8. Well Name and No.
WERSSELL FEDERAL 29. API Well No.
30-015-24845-00-S110. Field and Pool, or Exploratory
ESPERANZA11. County or Parish, and State
EDDY COUNTY, NM

** BLM REVISED ** BLM REVISED ** BLM REVISED ** BLM REVISED ** BLM REVISED **

Wersell Federal #2 SWD

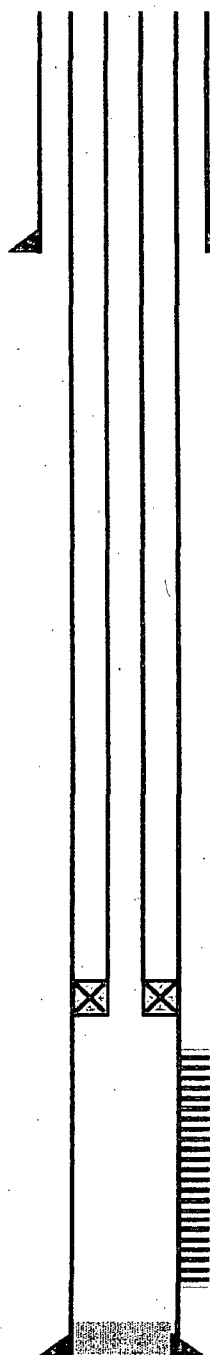
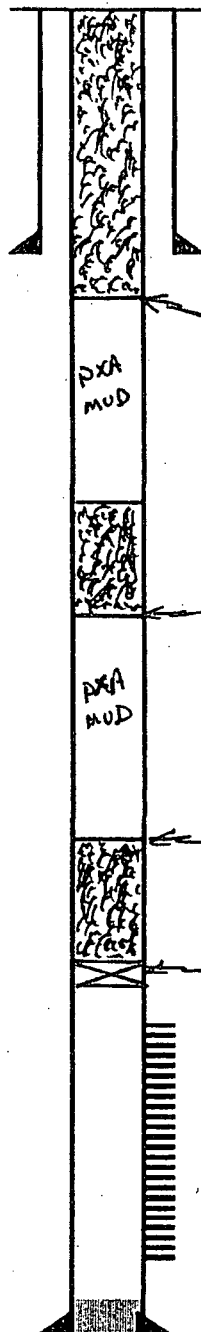
- 1) SET 5-1/2" CIBP @ 2,750'; PUMP 25 SXS.CMT. @ 2,750'-2,620'.
 - 2) PRES. TEST 5-1/2" CSG. @ 500# X HOLD FOR 15 MINS.
 - 3) PUMP 25 SXS.CMT. @ 1,042'-1,822' (T/DLWR.). 1770'-165'
 - 4) MIX & CIRC. TO SURF. 60 SXS.CMT. @ 457'-3'(8-5/8" CSG.SHOE).
 - 5) DIG OUT X CUT OFF WELLHEAD 3' B.G.L.; WELD ON STEEL PLATE TO CSGS. X INSTALL DRY HOLE MARKER.
- DURING THIS PROCEDURE WE PLAN TO USE THE CLOSED-LOOP SYSTEM W/ A STEEL TANK AND HAUL CONTENTS TO THE REQUIRED DISPOSAL, PER OCD RULE 19.15.17.

CIRC. 60 SXS @ 457'-3'

1770-1650

Pump 25 SXS @ 1942'-1822'

Pump 25 SXS @ 2750'-2620'

SET 5 1/2" CIBP @ 2750'
